Service Bulletin

SUBJECT: Service Update for Inventory and Customer Vehicles
Windshield Washer Fluid Bottle Leaking
Expires with Base Warranty

MODELS: 2014 Chevrolet Corvette

Subject: 14577 – Service Update Bulletin
Windshield Washer Fluid Bottle Leaking

3997943

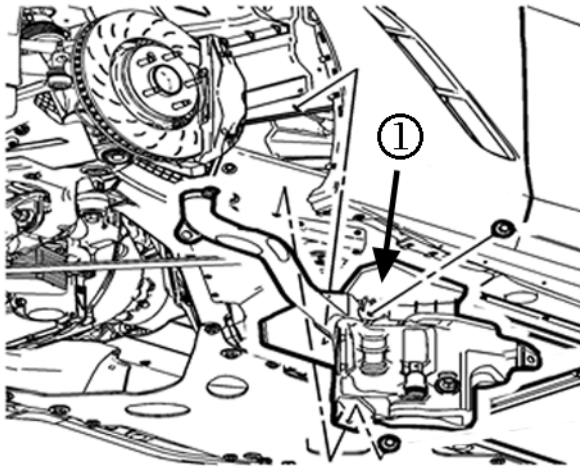
This bulletin provides a service procedure to replace on **certain** 2014 model year Chevrolet Corvette vehicles the windshield washer fluid bottle. These vehicles may have a washer fluid bottle that may leak and reduce the capacity of the washer bottle, or completely empty the washer bottle up to the crack, depending on the crack location and size.

1. Remove the windshield washer solvent container (1). Refer to *Windshield Washer Solvent Container Replacement* in SI.
2. Install the new windshield washer solvent container. Refer to *Windshield Washer Solvent Container Replacement* in SI.
